SUBJECT: CRYSTAL RIVER UNIT 3 - ISSUANCE OF AMENDMENT RE: STORAGE OF FUEL  
(TAC NO. 71815)

AMENDMENT NO. 119 TO FACILITY OPERATING LICENSE NO. DPR-72-CRYSTAL RIVER UNIT 3

SAFETY EVALUATION BY THE OFFICE OF NUCLEAR REACTOR REGULATION  
SUPPORTING AMENDMENT NO. 119 TO FACILITY-OPERATING LICENSE NO. -DPR-72

Figure 3.9-1  
Minimum Required Fuel Assembly Burnup as a Function  
of Initial Enrichment to Permit Storage in Pool A

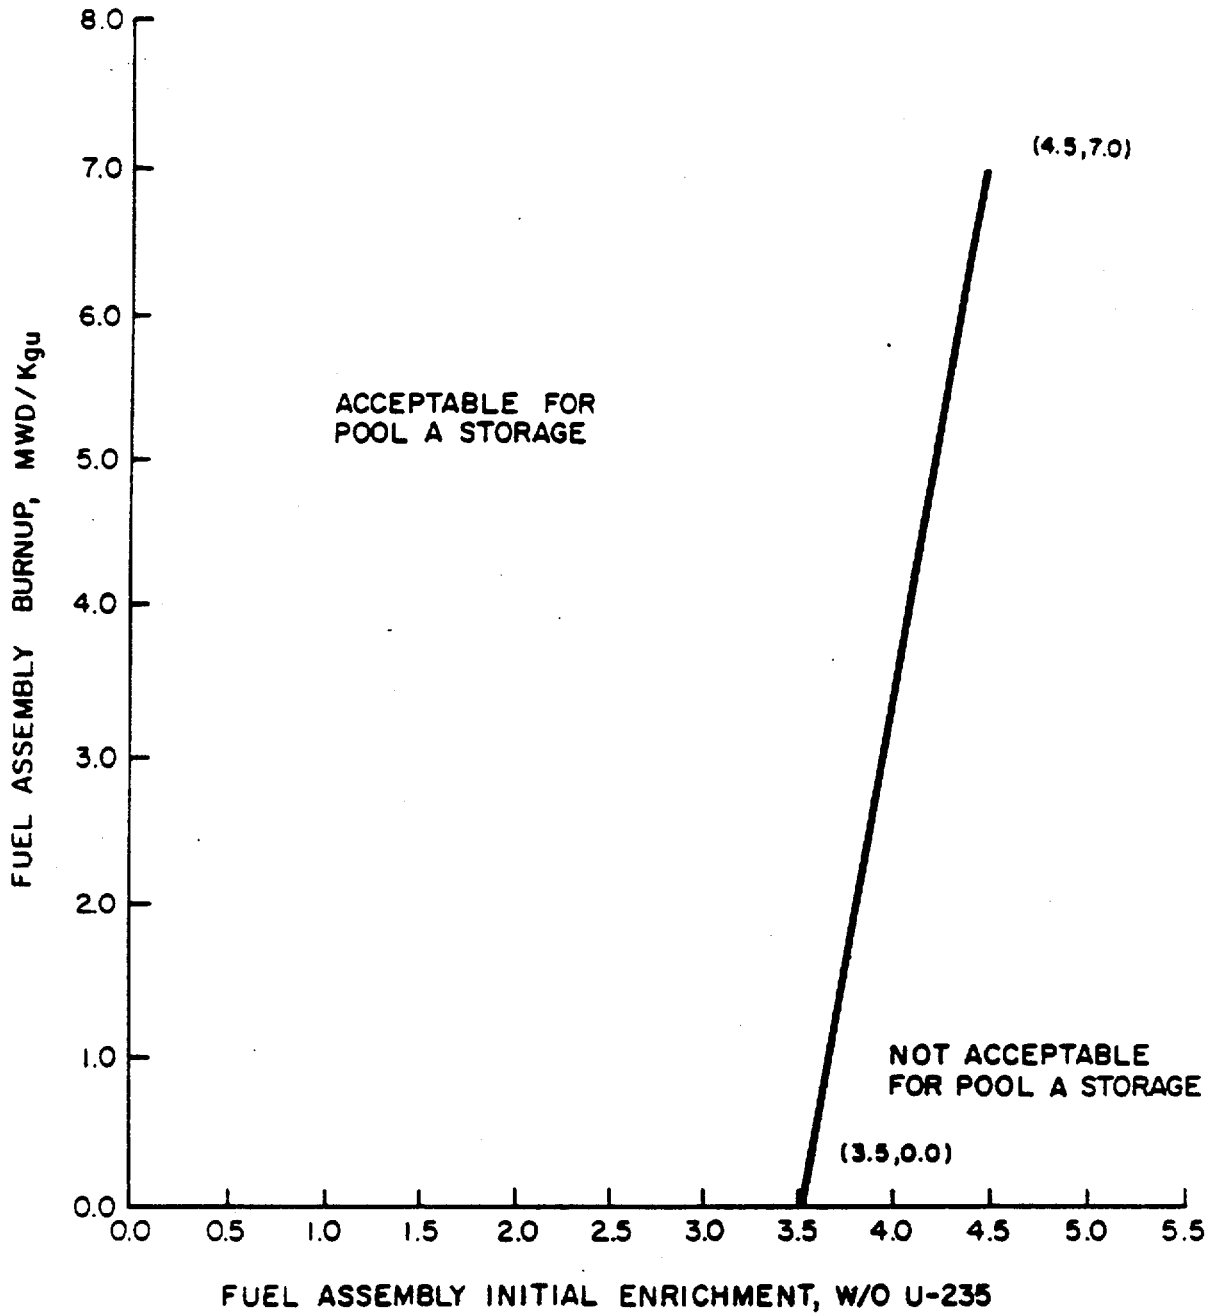
<u>LOCATION</u>	<u>CONDITION</u>
1. Dry fuel storage racks	New fuel with initial enrichment $\leq$ 4.5 weight percent U-235
2. Storage Pool A	Fuel with initial enrichment and burnup in accordance with Figure 3.9-1 but $\leq$ 4.5 weight percent U-235
3. Storage Pool B	Fuel with initial enrichment $\leq$ 4.0 weight percent U-235

- 4.9.13.1 Verify the initial enrichment of new fuel assemblies  $\leq$  4.5 weight percent U-235 prior to storage in the dry fuel storage racks.
- 4.9.13.2 Perform an INDEPENDENT VERIFICATION of the initial enrichment and burnup of fuel assemblies in accordance with Figure 3.9-1, prior to storage in the pool A storage racks. A complete record of such analysis shall be kept for the time period that the fuel assembly remains in the pool A storage racks.
- 4.9.13.3 Verify the initial enrichment of fuel assemblies  $\leq$  4.0 weight percent U-235 prior to storage in pool B storage racks.

The purpose of limiting the combination of allowable fuel enrichment and burnup of assemblies stored in pool A is to assure a sufficient safety margin to prevent inadvertent criticality. Values for initial enrichment and burnup are selected to maintain a keff less than or equal to 0.95. The spent fuel racks in storage pool A at CR-3 are currently licensed to store new fuel of 3.5% enrichment. The licensee presented an analysis to determine the minimum discharge burnup required for fuel of higher initial enrichment to be safely stored in the pool A storage racks. Calculations for initial enrichments ranging from 3.5% to 4.5% were performed and a curve defining the acceptable burnup domain was generated.

In performing the criticality safety calculations, the CASMO-2E and 123-group AMPX-KENO methods were used. The CASMO-2E proved to be slightly more conservative and yielded a maximum keff of 0.9474 for fuel of 4.5% initial enrichment and burned to a minimum of 7.0 Mwd/kg-U. In addition, calculations show that, in the long-term, after decay of xenon, reactivity decreases as Plutonium-241 decays.

Since the storage of fuel of initial concentration of 4.5% enrichment and burned to 7.0 Mwd/kg-U will not result in a keff of greater than 0.95 in storage pool A, and since the decay heat generated by this fuel is within the heat removal capability of the storage pool cooling system, storage of this fuel in storage pool A is acceptable.
